SHOP DRAWING / SUBMITTAL REVIEW

THE DYLAN & JAMIE
ROY FAMILY
WIND PRESSURE FOR
WINDOWS
6783 SW 104TH ST.
PINECREST FLORIDA

S-1

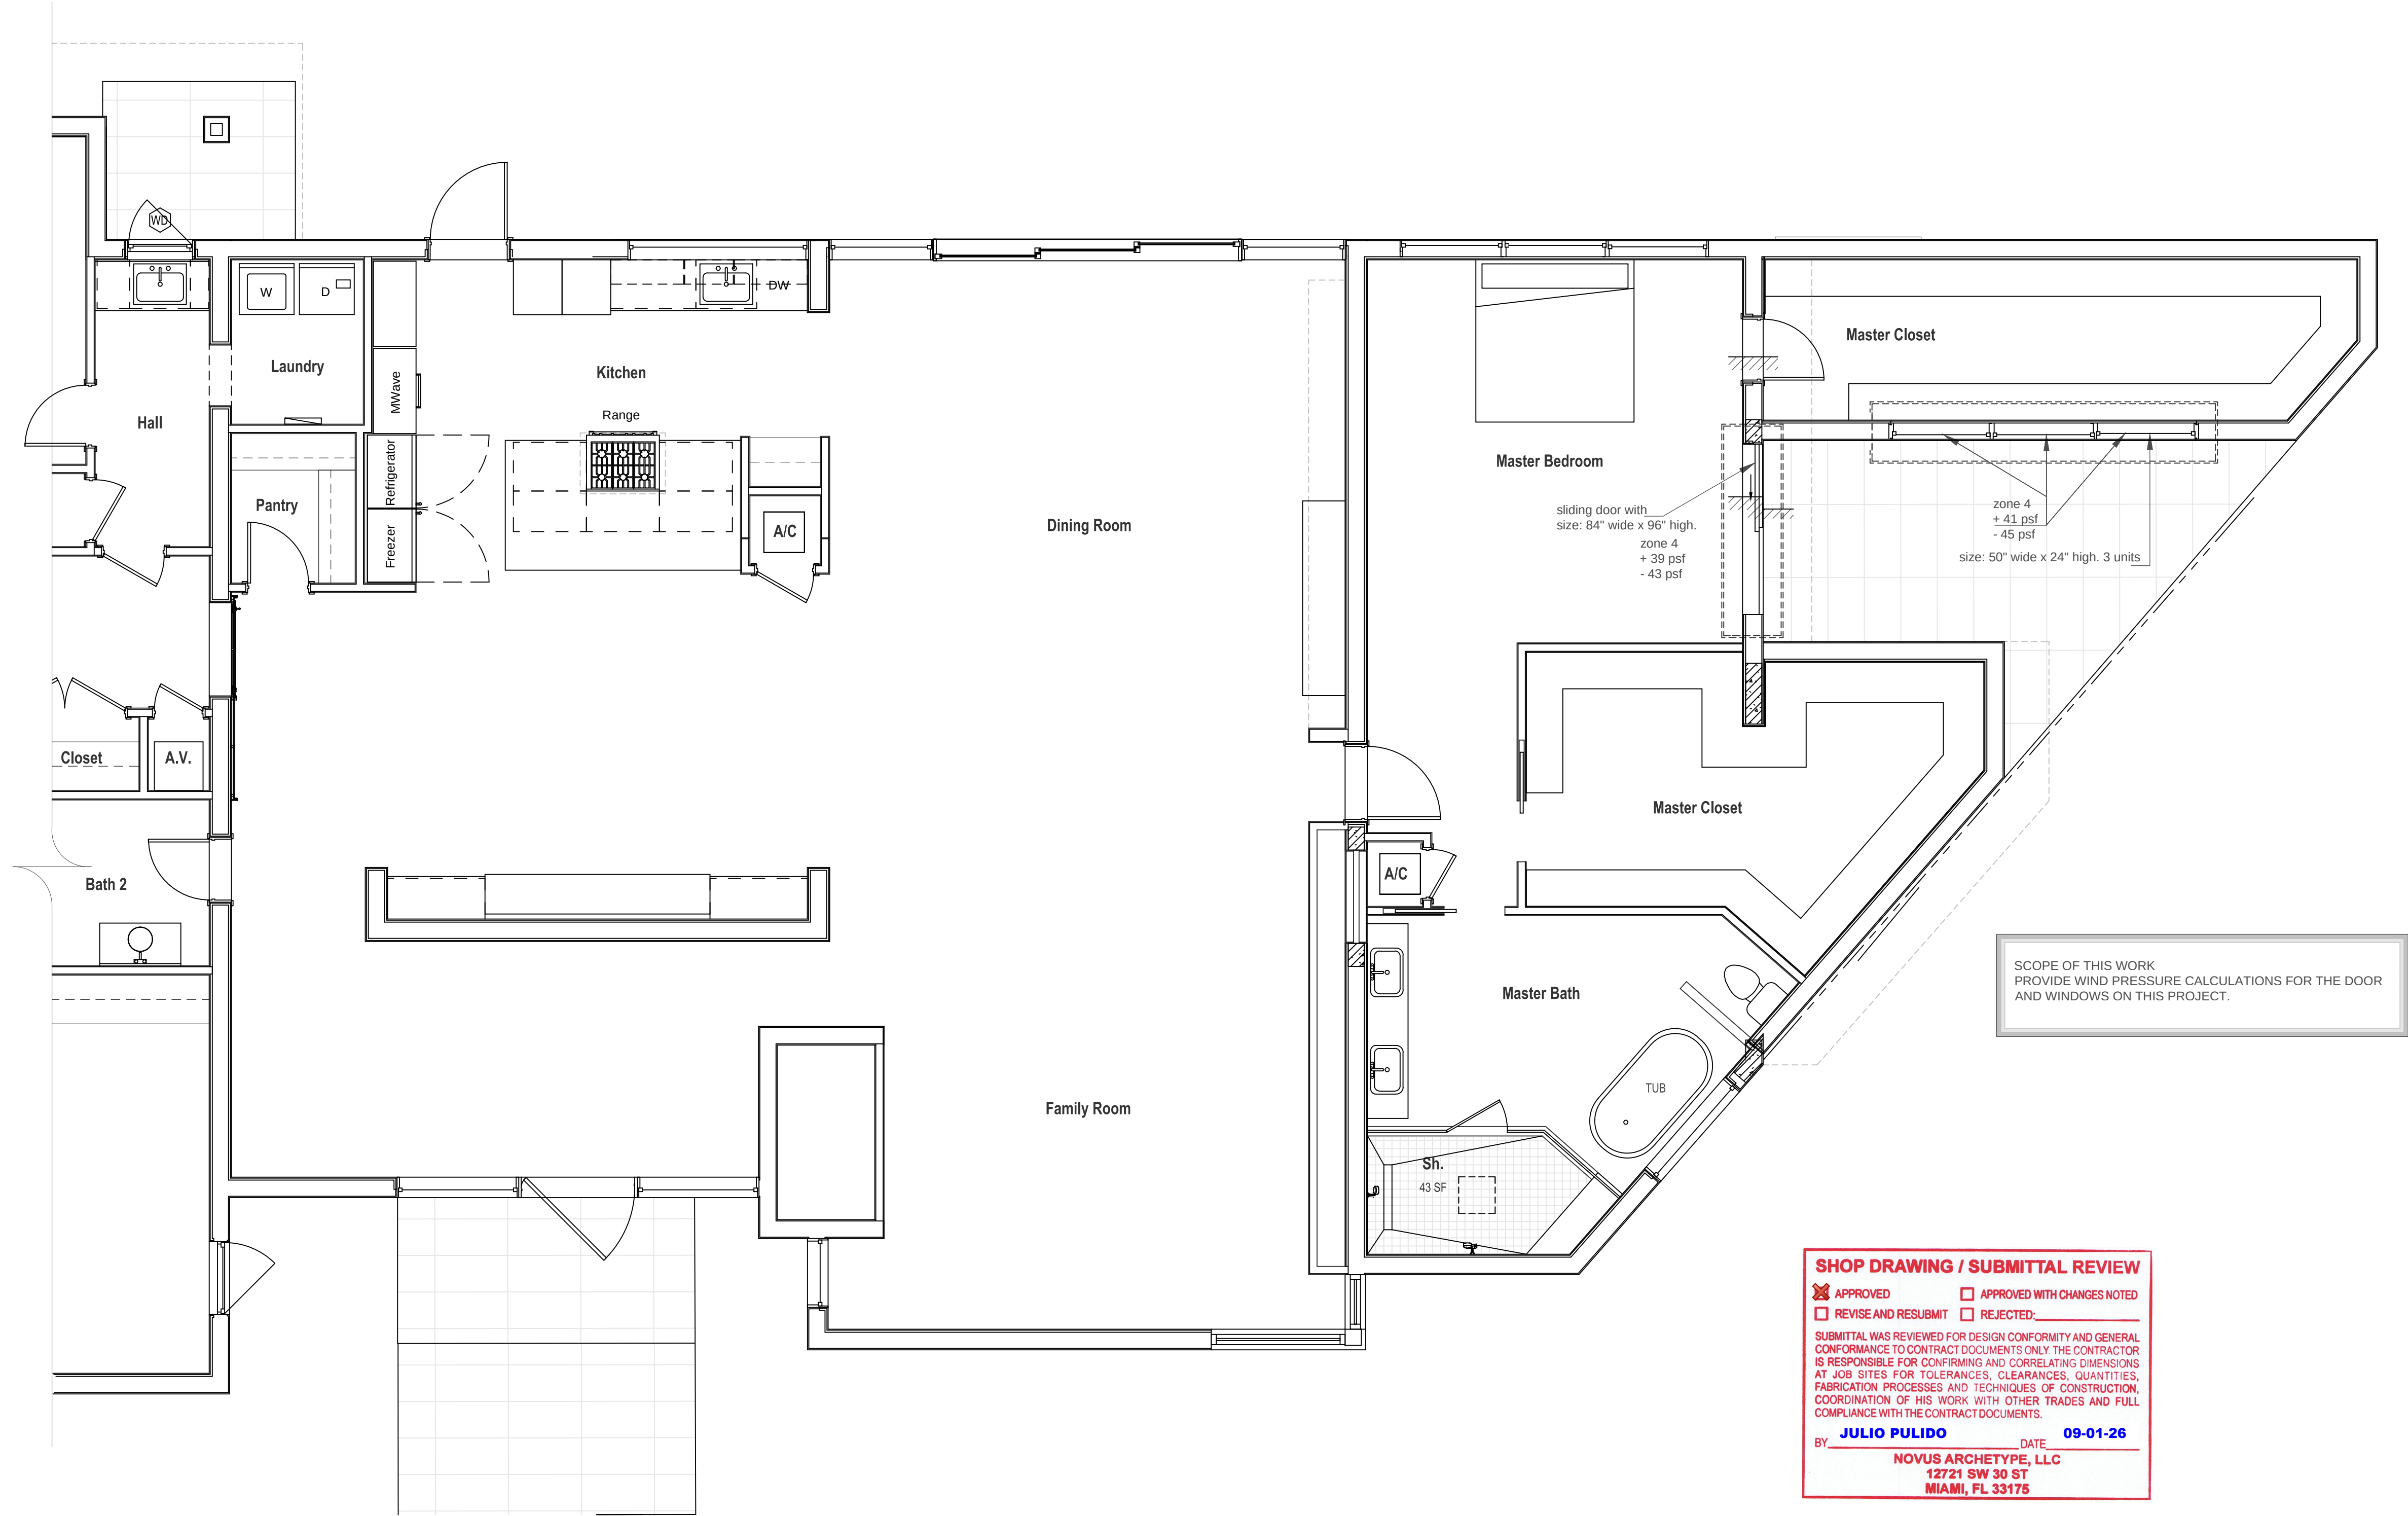
☒ APPROVED	☐ APPROVED WITH CHANGES NOTED
☐ REVISE AND RESUBMIT	☐ REJECTED

SUBMITTAL WAS REVIEWED FOR DESIGN CONFORMITY AND GENERAL CONFORMANCE TO CONTRACT DOCUMENTS ONLY. THE CONTRACTOR IS RESPONSIBLE FOR CONFIRMING AND CORRELATING DIMENSIONS AT JOB SITES FOR TOLERANCES, CLEARANCES, QUANTITIES, FABRICATION PROCESSES AND TECHNIQUES OF CONSTRUCTION, COORDINATION OF HIS WORK WITH OTHER TRADES AND FULL COMPLIANCE WITH THE CONTRACT DOCUMENTS.
